Number	Description
1	Revised Bid Items; Revised or Added Plan Sheet Nos. 8001-8003, 8011; Amendment EBS Download Required.

Bridge Replacement on SR 4 over the BNSF Railway & MS Central Railroad Company, Bridge No. 75.3, known as Federal Aid Project No. BR-0060-03(020) / 105333301 in Marshall County.

ADDENDUM

STATE MISS. PROJECT NO. BR-0060-03(020)

MISSISSIPPI DEPARTMENT OF TRANSPORTATION
OVERPASS AT STA. 116+31.45
BIRMINGHAM SUBDIVISION RR MP 528.35
SR 4 ACROSS BNSF RAILWAY &
MS CENTRAL RAILROAD CO.
LAYOUT - EXHIBIT "B-1"

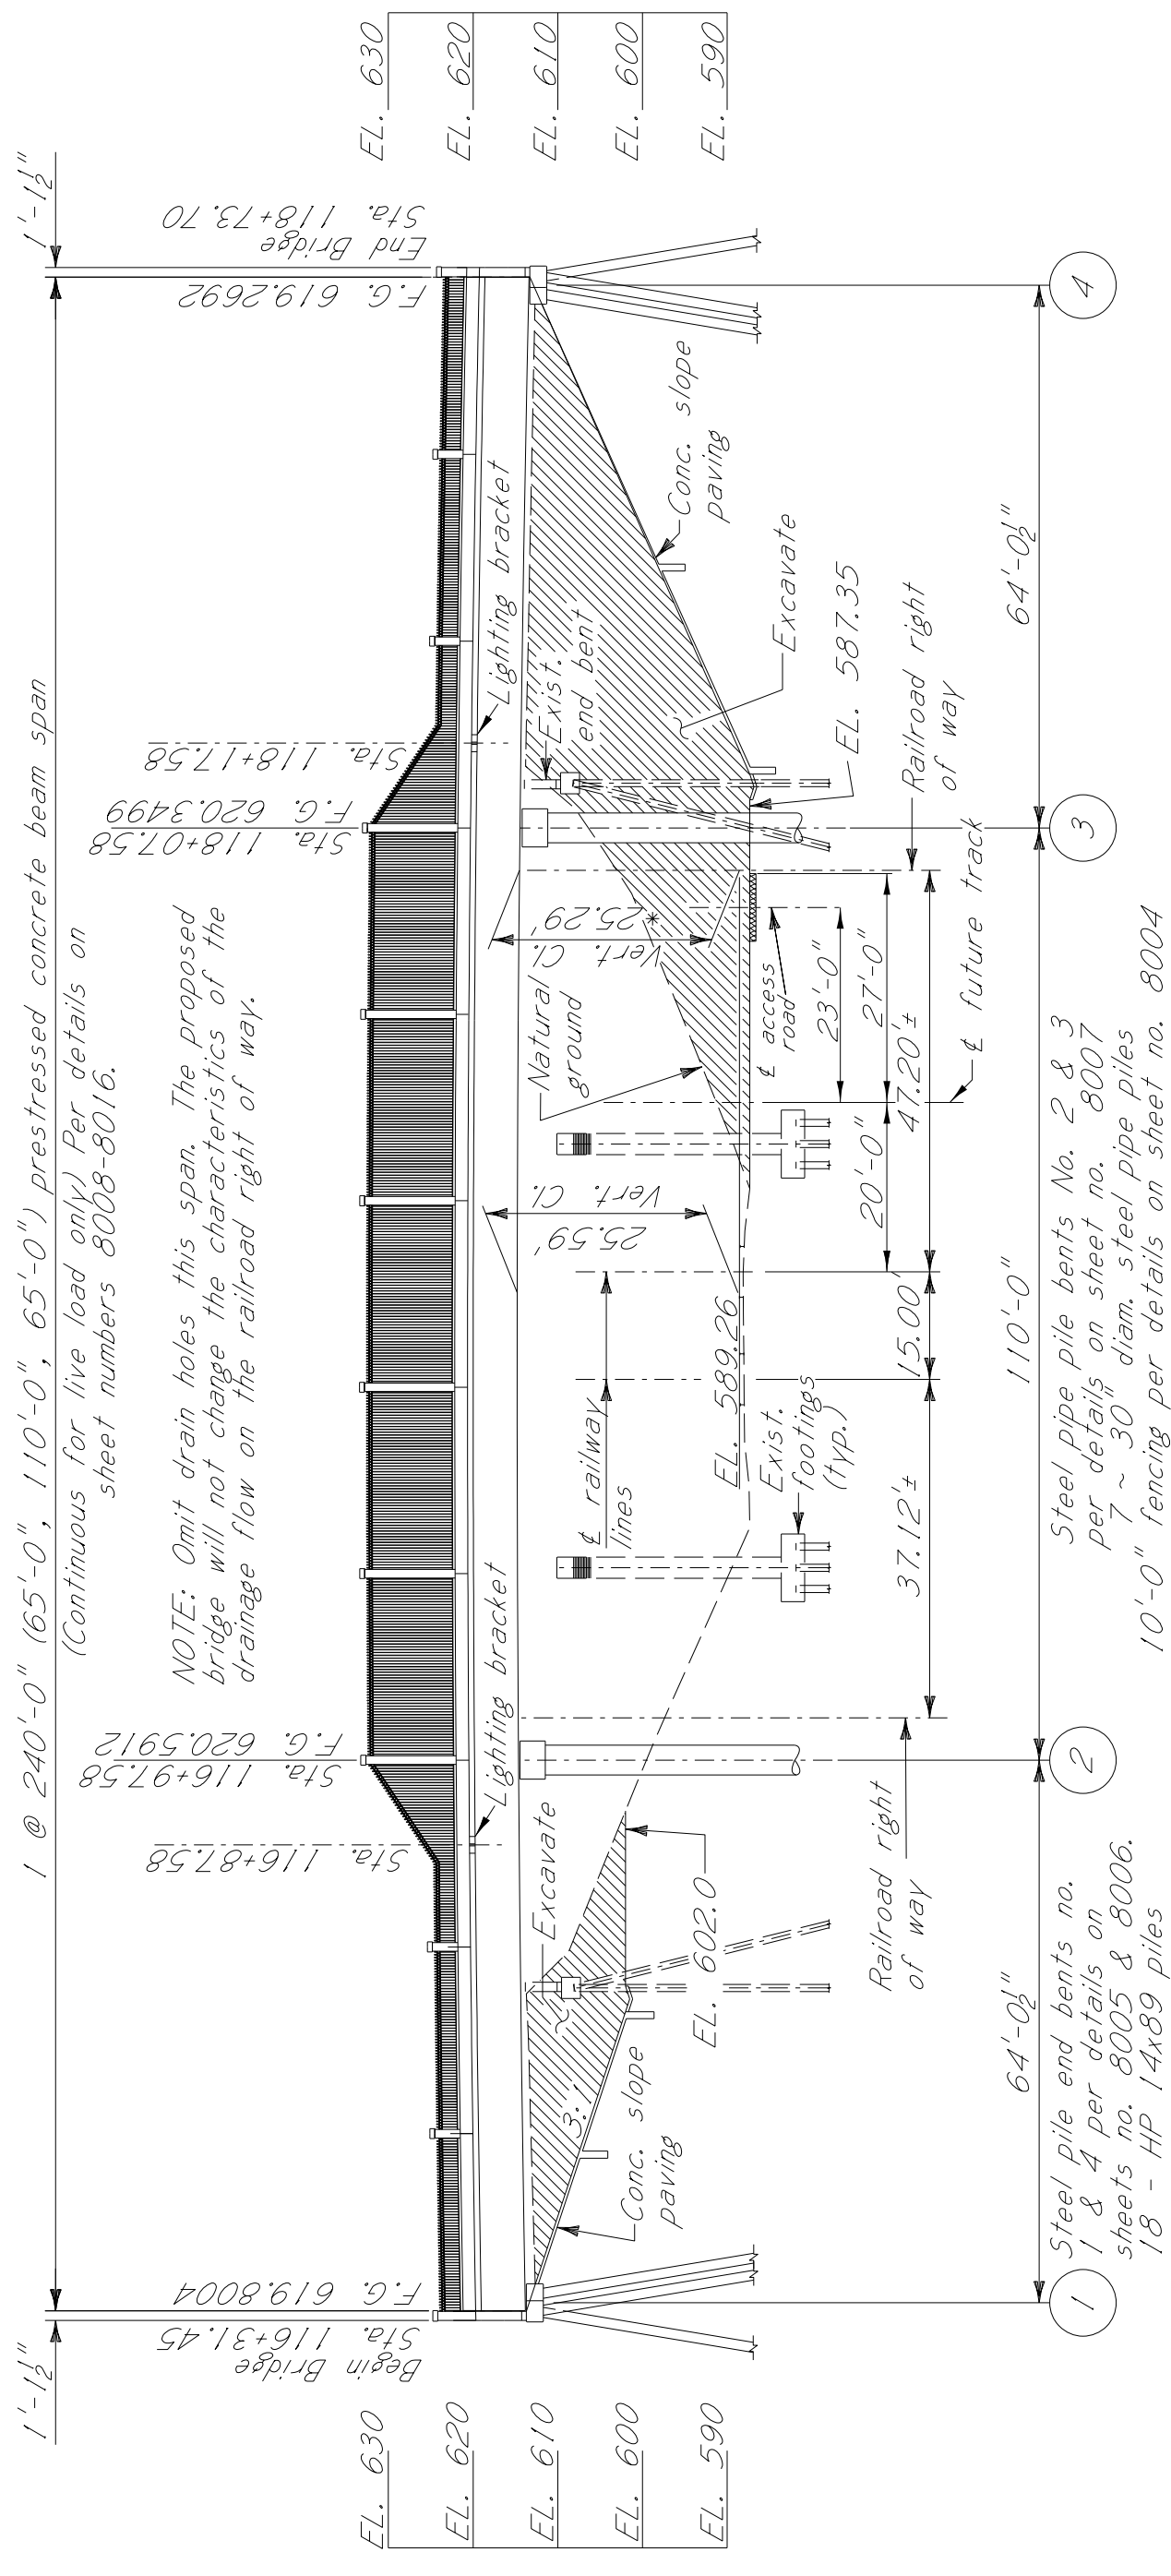
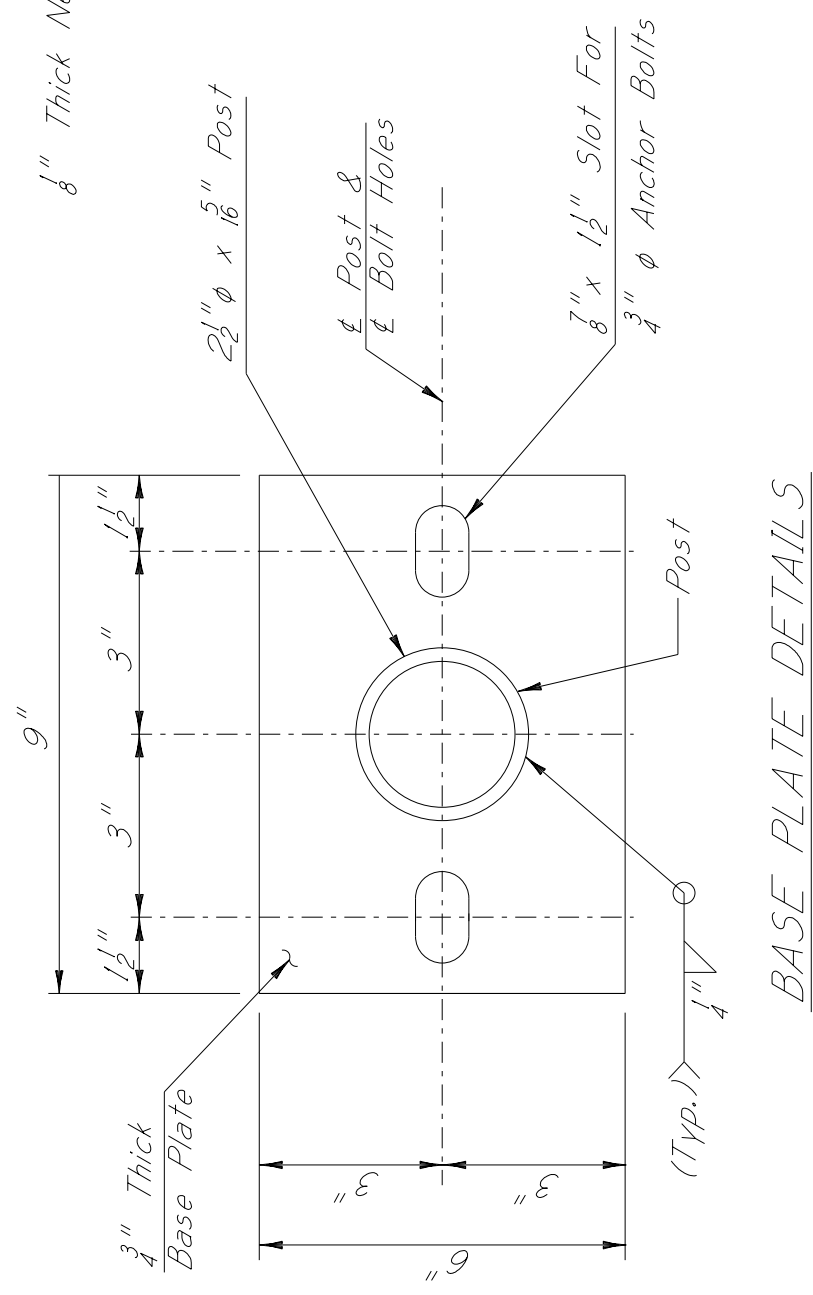
DATE: 9/11/19
REVISION: Removed Test Pile

WORKING NUMBER
 9 OF 14
 SHEET NUMBER
 8011

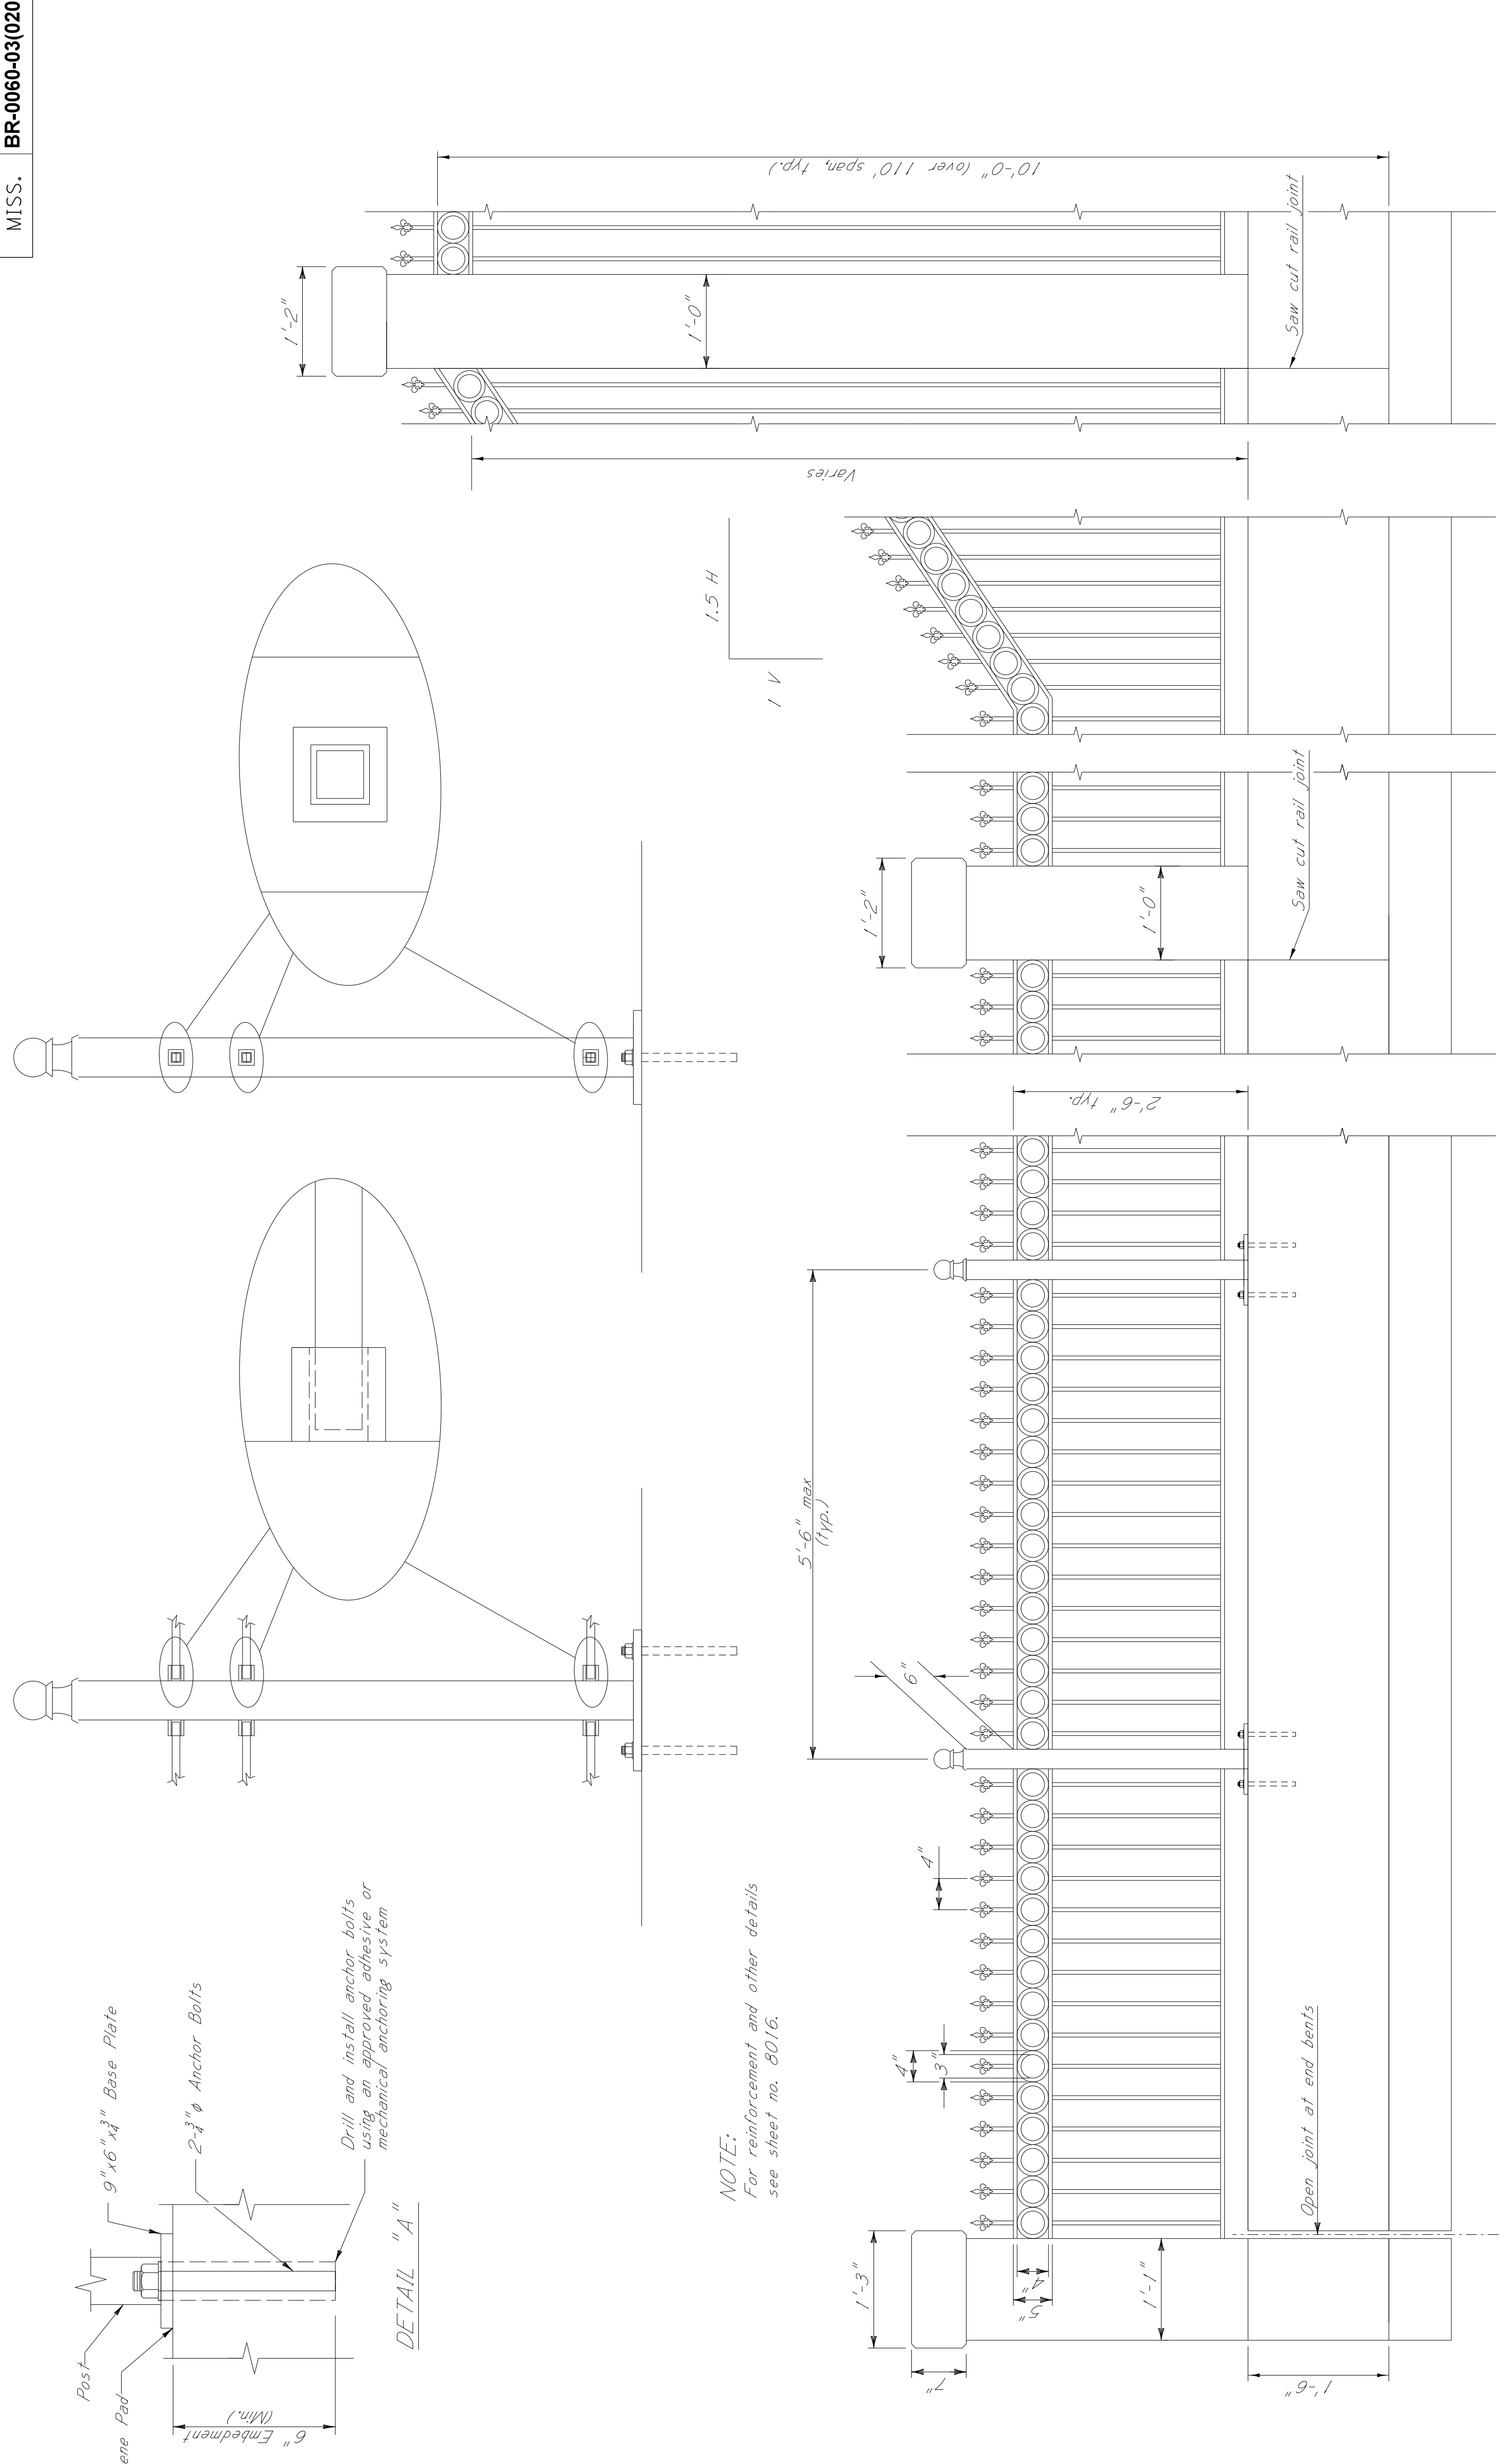
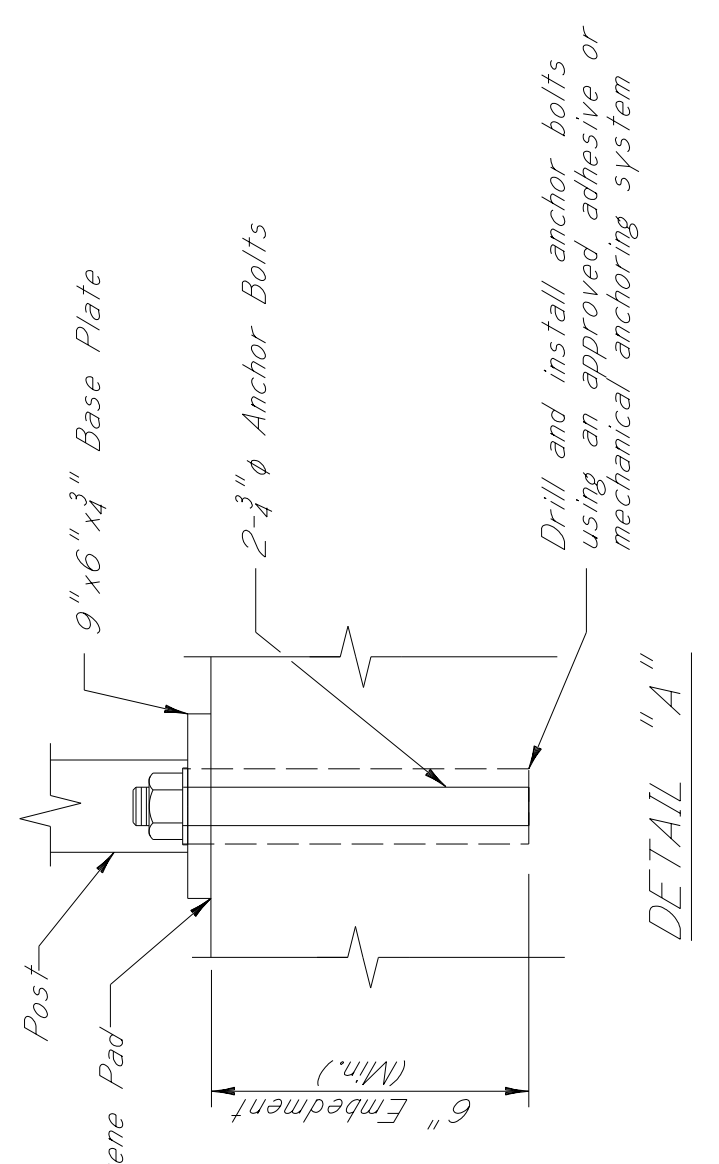
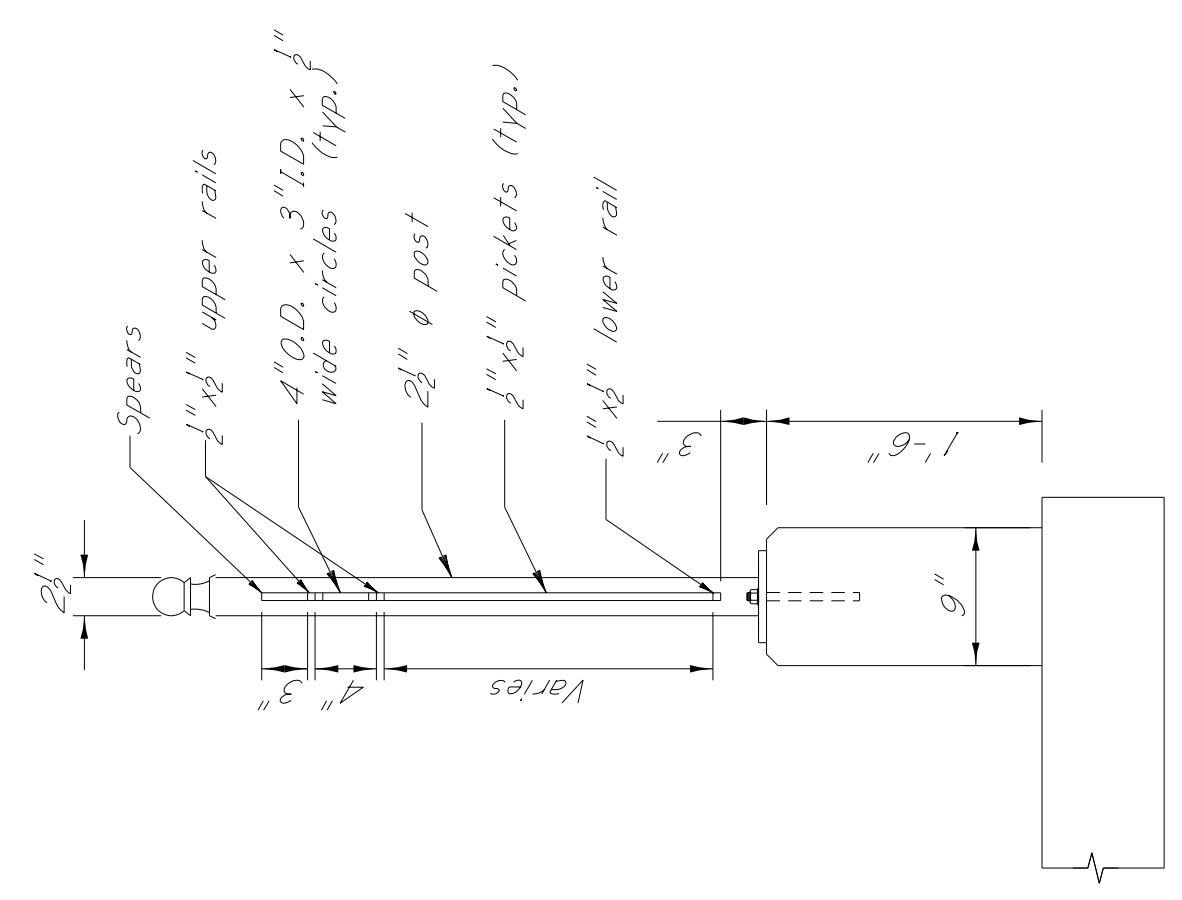
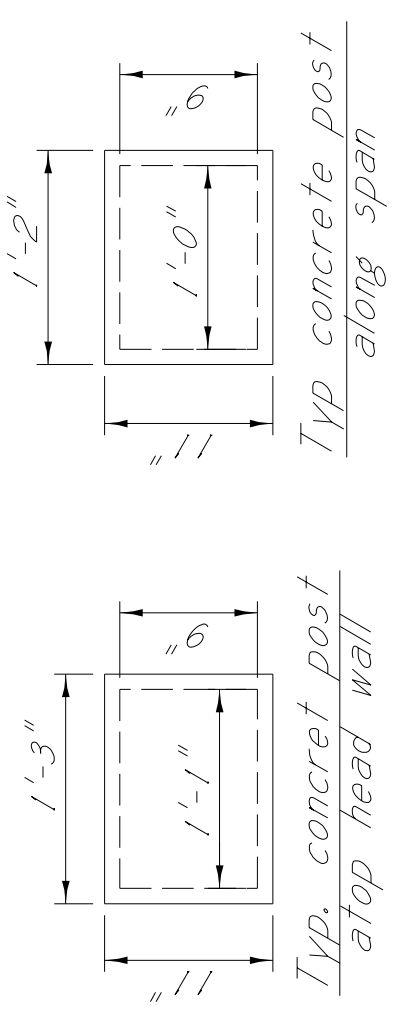
DATE	REVISION	BY
9/11/19	Added Note	FLW

PAINT NOTE:
 Structural steel surfaces shall be cleaned and then painted with one shop coat of inorganic zinc, one field intermediate coat of zinc rich epoxy primer and one top coat of inorganic zinc. Final top coat shall be gloss black. (Not a separate pay item. Paint and coating shall be absorbed under pay item 813-8001, Concrete-Steel Railings.)
